| <i>NCSX RFD</i> <i>Part I</i> | Number: 14-017 | RFD Description: Thermocouple Hole Changes |
| State Requirement Deviation is Requested For: <i>(Specification, MIT/QA Plan, SOW, drawing, etc.): SE141-114</i> | | |

SE141-114 Type A
Thermocouple TC2-TC2

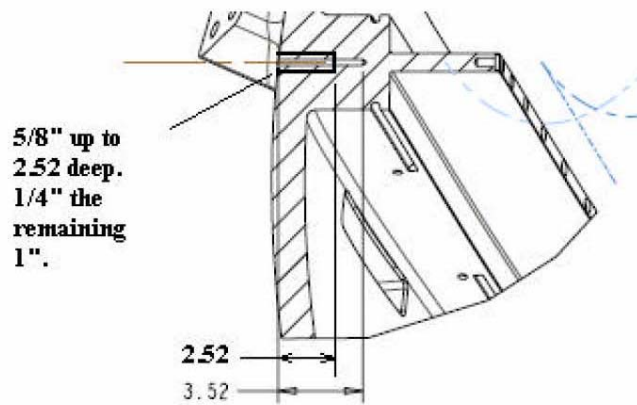
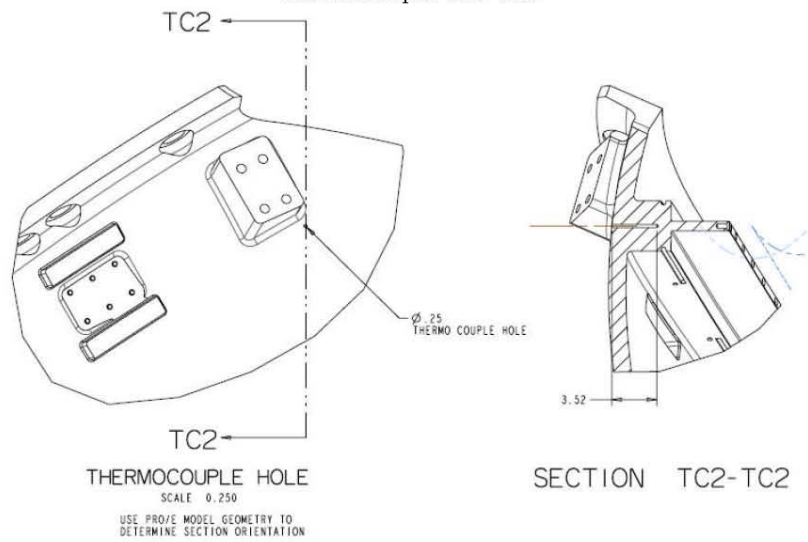
We are requesting a change to the thermocouple in section TC2-TC2 of drawing SE141-114 sheet 9 similar to what has already been approved on the thermocouple at location TC1-TC1.

To facilitate drilling of the thermocouple hole shown in drawing Number SE 141-114, sheet 9, the diameter of the 8.2 inch deep thermocouple hole will be increased to 5/8" for the first 7.2 inches of depth, followed by a diameter of 0.25 inch for the remaining 1 inch depth.
